Change logs:

VERSA 1.09   2017-08-10

DLOADX 1.17.002   2017-07-26

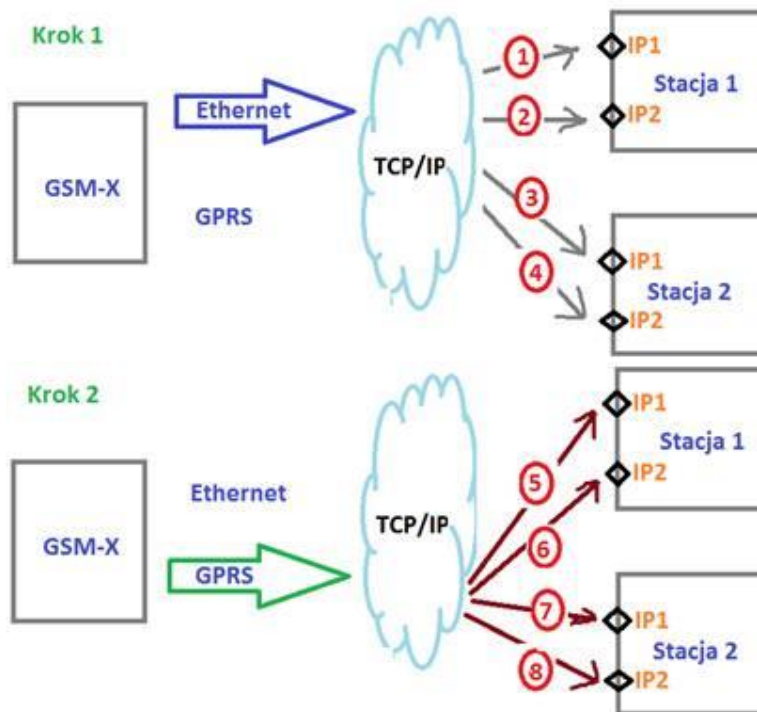
Dual Path Reporting is new requirement of ATS6, which is a norm for the communication modules under GRADE 3. In case of event the communication, performed on any type of communication, will be sent to 2 indipendend monitoring stations. Check the pictrures below.
